INITIAL FIRE SAFETY INSPECTION REPORT

GENESIS FASHIONS LTD. (Extension - 2)

RSC ID: 26201

Date: 21 April, 2025

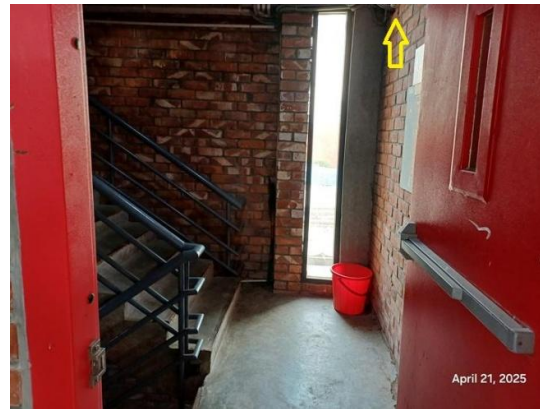
SI No.	Category	Findings	Required Action	Remediation Time Frame
F-76	Means of Egress	<p>Unsealed penetrations and openings are located in exit stair enclosures. Electrical cable/ BBT raceway passing through the exit enclosure.</p> <p>Location: Mid-East stair-1 of 3 Storied Daycare, Medical & Dining Building</p>	<p>No other penetration into and through the exit enclosure except for fire alarm equipment electrical raceway, required exit doors, sprinkler piping, standpipes, and electrical conduit serving the exit enclosure is permitted in accordance with section 6.14.4 of RSC Technical Guidelines (Standard)¹ V1.0. So, relocate the electrical wires/raceways to somewhere else avoiding the exit enclosure, and seal the created unprotected openings with a minimum of 1.5 hours listed/certified fire-rated materials. Installation shall be as per manufacturer published installation guideline and the certification authority guideline to ensure the fire-rating. Or seal the penetration by 2-hr masonry construction.</p>	Within 3 Months

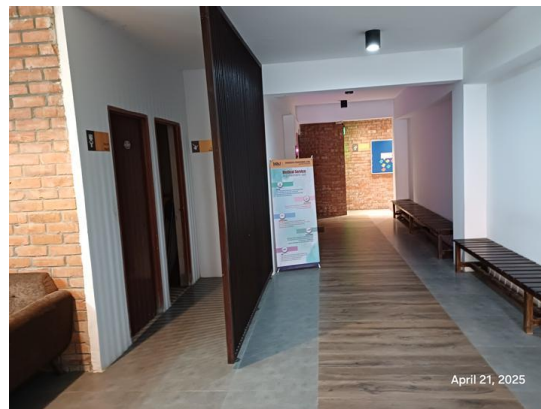
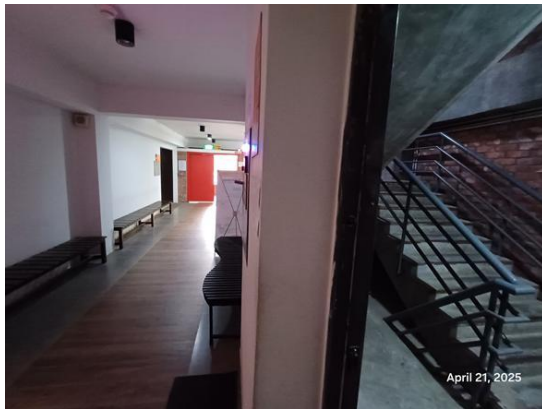
SI No.	Category	Findings	Required Action	Remediation Time Frame
F-77	Means of Egress	<p>Exit stair-1 (Mid-East) terminates the occupants inside the building which does not comply with section 6.17 of RSC Technical Guidelines (Standard)¹ V1.0.</p> <p>Location: Mid-East stair-1 discharge on ground floor of 3 Storied Daycare, Medical & Dining Building</p> <p>Non-compliance reason: On ground floor, Unsealed openings are found from medical, daycare and toilet zone.</p>	<p>Exits shall discharge directly to the exterior of the building unless meeting the requirements of 6.17.2 or 6.17.3 as per RSC Technical Guidelines (Standard)¹ V1.0.</p>	Within 3 Months

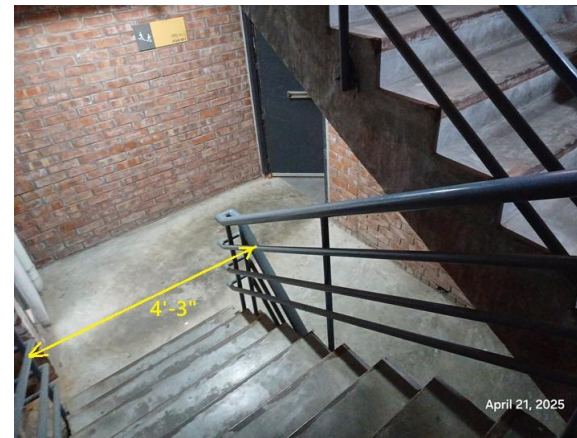
SI No.	Category	Findings	Required Action	Remediation Time Frame
F-80	Means of Egress (Exit Adequacy)	<p>Each of the two Stairs clear width is found less than 79 in. (Width of Stair-1 and stair-2 is 4'-3" and 4'-5" respectively.</p> <p>Location: Mid-South Stair-1 and North-West Stair-2 in 3 Storied Daycare, Medical & Dining Building</p>	<p>Stairs shall have a minimum clear width of 79 in. for all assembly occupancies as per RSC Technical Guideline (Standard) section of 6.5.6</p> <p>Landings with same width as the stair clear width shall be provided at each level and at intermediate landings as per RSC Technical Guideline (Standard) section of 6.9.2.2.</p>	Within 3 Months
